## ADDENDUM NO. 1

Reference: Staff Restroom Upgrades – Bonneville and Fremont CCCs  
Division of Adult Probation and Parole – Salt Lake City, Utah  
DFCM Project No. 09199120

**Addendum No. 1**

Project: Staff Restroom Upgrades Bonneville & Fremont Date: 22 March 2010  
Address: 1141 S. 2475 W. & 2588 W. 2365 S. Project No.: DFCM 09199120 / HFSA 1004.01  
City, State: Salt Lake City, Utah Agency: Utah Department of Corrections

**AE901**  
SHEET 5 OF 5

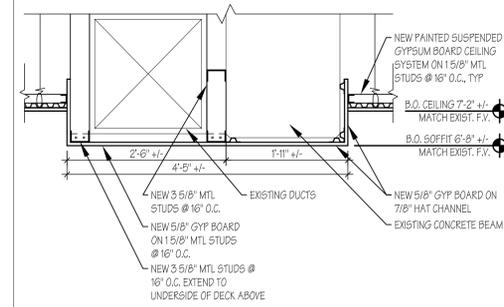
1 -8	Question AE101 09310	<p>Bonneville: Are we glueing the new floor tile down to the concrete?</p> <p><b><i>Answer: No. The new floor tile will be thin set. See Spec Section 09310.</i></b></p>
1 -9	Question AE101 09310	<p>Bonneville: Do we really want to use a trap primer connection? It will require trenching the floor to install.</p> <p><b><i>Answer: Yes. See General Note 3 on AE101 and AE102 regarding means and methods.</i></b></p>
1 -10	Question AE101	<p>Bonneville: Are the door swings on the new doors switched?</p> <p><b><i>Answer: Yes. See plans on sheet AE101.</i></b></p>
1 -11	Question AE101	<p>Bonneville: Do we want to put in surface mounted fire alarms rather than the existing wall mounted fire alarms in the restrooms?</p> <p><b><i>Answer: No.</i></b></p>
1 -12	Question AE901	<p>Bonneville: How do you want the new hard lid ceiling framed for the second floor dorm room and break room?</p> <p><b><i>Answer: See existing ceiling plan legend and revised ceiling plan and soffit detail on revised sheet AE901, attached at the end of this addendum.</i></b></p>

1 -13	Question AE901	<p>Bonneville: Are we replacing the mechanical grills, smoke detectors and exit signs in the second floor dorm room and break room?</p> <p><b><i>Answer: Yes, Replace existing ceiling diffusers and return air grilles with new complete frame for mounting in solid ceiling. Field verify neck sizes. See revised ceiling plan on revised sheet AE901 and new schedules, plans and notes on new electrical sheet E-101, all attached at the end of this addendum.</i></b></p>
1 -14	Question AE901	<p>Bonneville: What type of lights are we using in the new hard lid ceiling for the second floor dorm room and break room?</p> <p><b><i>Answer: See the detail fixture schedule D3/E-101 and Partial Level 2 New Electrical Plan A2/E-101 and Keyed Notes E-101, attached at the end of this addendum.</i></b></p>

Item No.	Section or Sheet No.	Description
1 -15	Question AE901	<p>Bonneville: Does the new hard lid ceiling for the second floor dorm room and break room need access panels?</p> <p><b>Answer: Yes. Provide 24" X 24" Babcock-Davis B-NW, or equal, Paintable Non-rated flush panel with drywall bead, key operated cylinder lock and stainless steel hinge. Provide all necessary blocking as required for installation of door. Provide one each in the break room and two each in the dorm room based on the locations of existing junction boxes in the ceiling.</b></p>
1 -16	Question AE102	<p>Fremont: The existing toilets are wall hung with a back to back single carrier. Plans call out to replace them with a floor mounted toilet. The existing walls and floor will have to be opened up and rough plumbing changed to install a floor mounted toilet. A new wall mount would make the job easier and less costly. However, the rough plumbing is too close to the wall to meet ADA requirements and needs to be moved east. Please advise. Changing the plumbing from a wall mounted fixture to a floor mounted one will require ceramic tile floor patch which could prove difficult at best to match the existing tile.</p> <p><b>Answer: Supply wall mounted toilets. Re-use the existing carriers for water closets. The toilets will be placed in there original locations which we believe meets ADA.</b></p>

SD-01

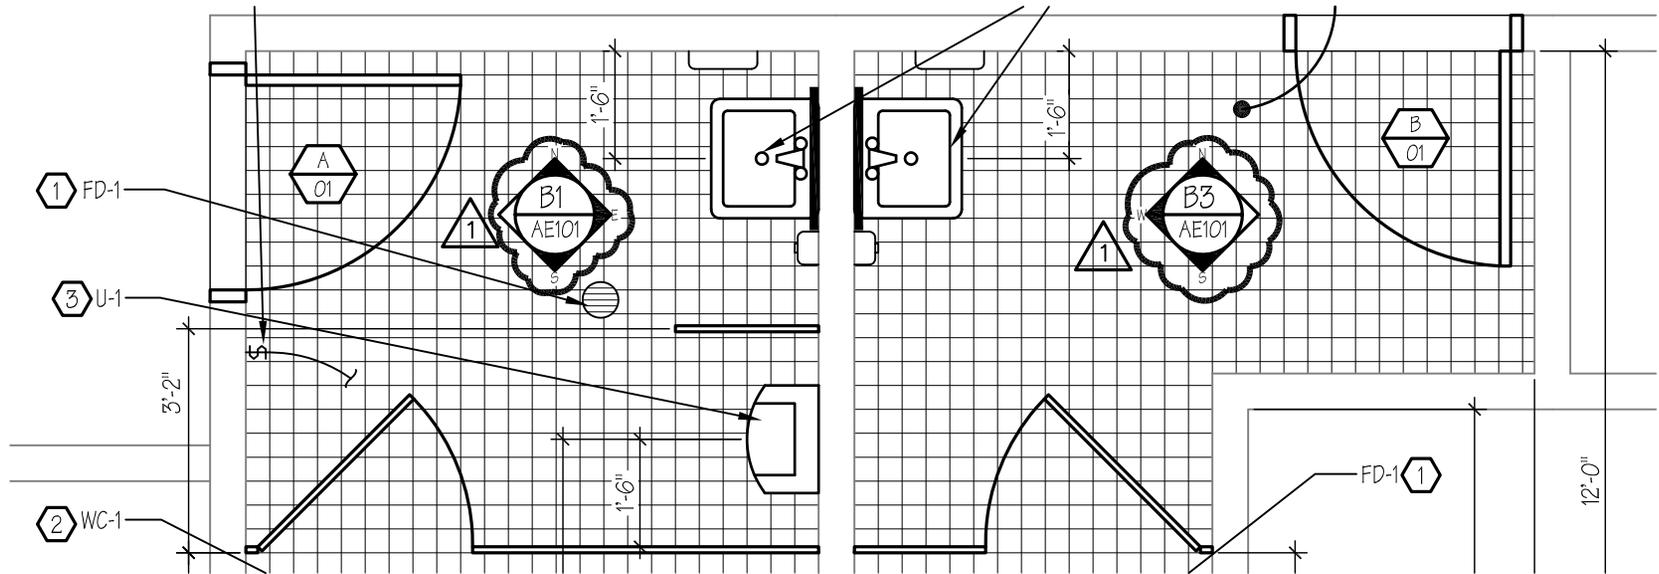
1 -21	GI001	Replace the 'Drawings Index' with the attached revised 'Drawing Index' SD-01.
1 -22	AE101	Restroom New Floor Plan A3: Change room M-1 elevation tag from 'B3/AE101' to 'B1/AE101'. See attached SD-02.
1 -23	AE101	Restroom New Floor Plan A3: Change room W-1 elevation tag from 'B1/AE101' to 'B3/AE101'. See attached SD-02.
1 -24	AE102	Men's Room Interior Elevations B1: Revise West and North Elevations per attached SD-03.
1 -25	AE102	Women's Room Interior Elevations B3: Revise West and South Elevations per attached SD-04.
1 -26	AE102	Restroom Demo Plan A1: Revise notation per attached SD-05.
1 -27	AE102	Restroom New Floor Plan A3: Revise fixtures per attached SD-06.
1 -28	AE901	Replace the sheet 'AE901 Alternate #1 Suspended Gyp. Bd. Ceiling Level 2 with the attached revised 'AE901 Alternate #1 Suspended Gyp. Bd. Ceiling Level 2'.
1 -29	E-101	Add the attached drawing: E-101 Alternate #1 Electrical Plans Level 2.
